RAI Volume 2, Chapter 2.1.1.7, Fifth Set, Number 1: The following questions pertain to DOE's design of the important-to-safety (ITS) controls and instrumentation relied on for safety functions of structures, systems, and components, described in SAR Sections 1.2.3, 1.2.4, 1.2.5, 1.2.6, 1.2.8, 1.3.3, 1.4.1, and 1.4.2. The information is needed to verify compliance with 10 CFR 63.112(f).

RAI Volume 2, Chapter 2.1.1.7, Fifth Set, Number 2: The following questions pertain to DOE's design of the important-to-safety (ITS) controls and instrumentation relied on for safety functions of structures, systems, and components, described in SAR Sections 1.2.3, 1.2.4, 1.2.5, 1.2.6, 1.2.8, 1.3.3, 1.4.1, and 1.4.2. The information is needed to verify compliance with 10 CFR 63.112(f).

RAI Volume 2, Chapter 2.1.1.7, Fifth Set, Number 3: The following questions pertain to DOE's design of the important-to-safety (ITS) controls and instrumentation relied on for safety functions of structures, systems, and components, described in SAR Sections 1.2.3, 1.2.4, 1.2.5, 1.2.6, 1.2.8, 1.3.3, 1.4.1, and 1.4.2. The information is needed to verify compliance with 10 CFR 63.112(f).

Figure 1. Annotated Logic Diagram Excerpt of SAR Figure 1.2.4-21 for Clarification of Isolation

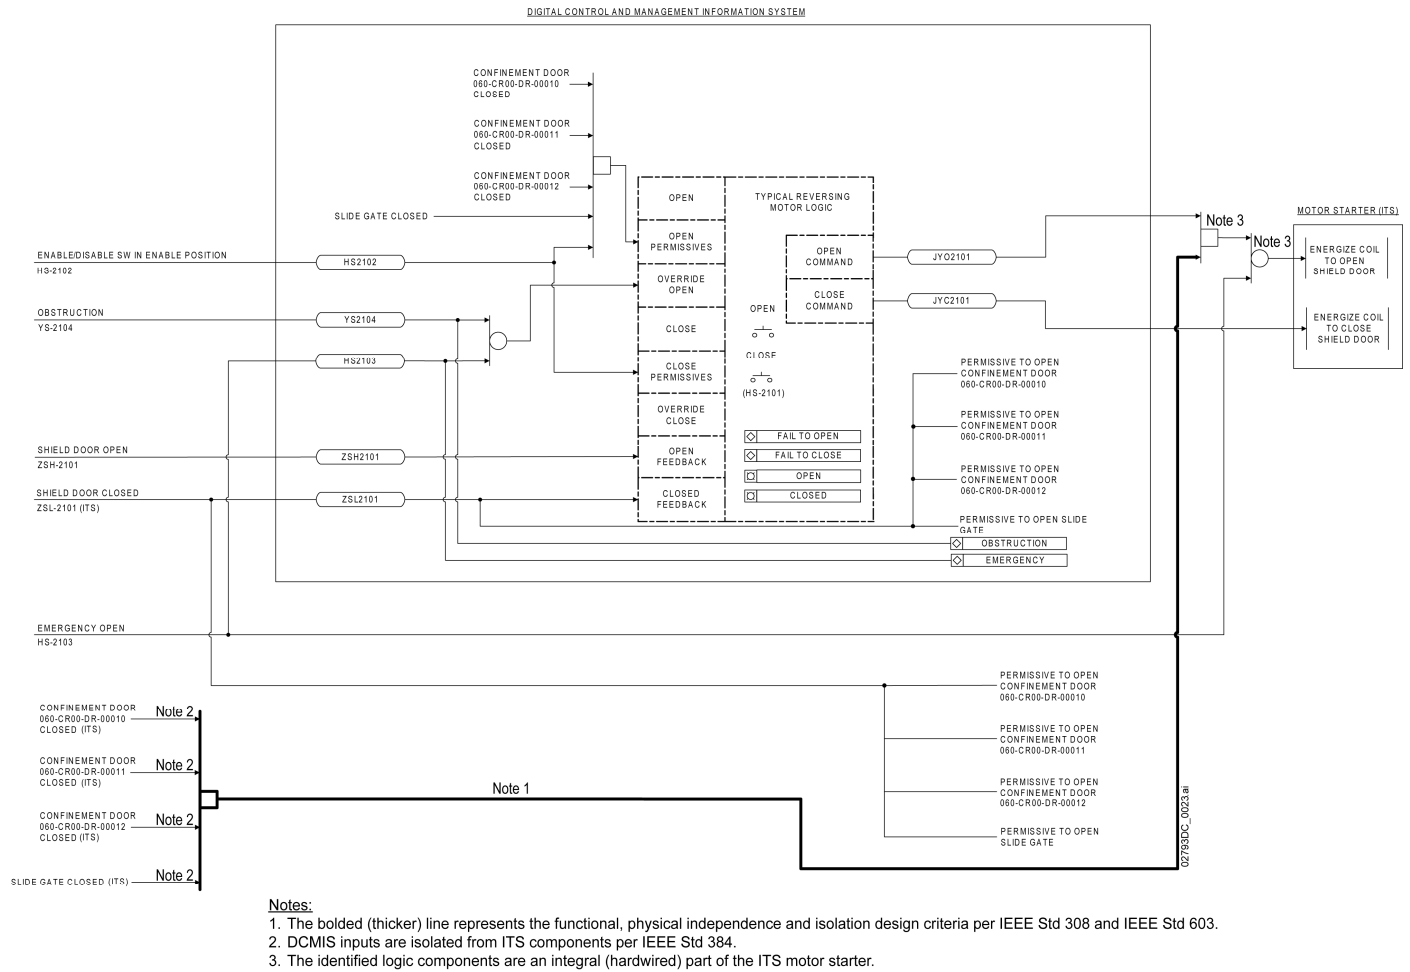
Clarify how separation of protection and control systems is met for independence and isolation characteristics of ITS controls, especially when ITS interlocks interface with non-ITS controls like Programmable Logic Controllers, Digital Control Management Information Management System logic interlock and various sensors and switches.

SAR Figure 1.2.4-21 represents a typical logic diagram for the Canister Receipt and Closure Facility, Initial Handling Facility and Wet Handling Facility. Figure 1 is an annotated excerpt from SAR Figure 1.2.4-21 and clarifies the functional application of isolation and separation within IEEE Std 308-2001, *IEEE Standard Criteria for Class 1E Power Systems for Nuclear Power Generating Stations*, IEEE Std 384-1992, *Standard Criteria for Independence of Class 1E Equipment and Circuits*, and IEEE Std 603-1998, *IEEE Standard Criteria for Safety Systems for Nuclear Power Generating Stations*. The bold line within Figure 1 demonstrates the isolation and independence characteristics of the ITS system from the non-ITS DCMIS (e.g., the DCMIS individual inputs do not interface with the hardwired ITS system inputs, and the ITS inputs bypass the non-ITS DCMIS). The logic diagram in Figure 1 indicates that a signal from the DCMIS system cannot energize the ITS motor starter coil to open a confinement door or slide gate until the ITS (hardwired) system indicates that each of the confinement doors and slide gate are fully engaged in the closed (fail-safe) position. Stated differently, the ITS components (e.g., switches, interlocks) will only allow one confinement door or slide gate to be open at a time.

In summary, separation and isolation requirements of the ITS controls are derived from the nuclear safety design bases in SAR Section 1.9 and implemented by IEEE Std 308-2001, IEEE Std 384-1992 and IEEE Std 603-1998. ITS hardwired components ensure that limits relied upon to mitigate event sequences are not surpassed.
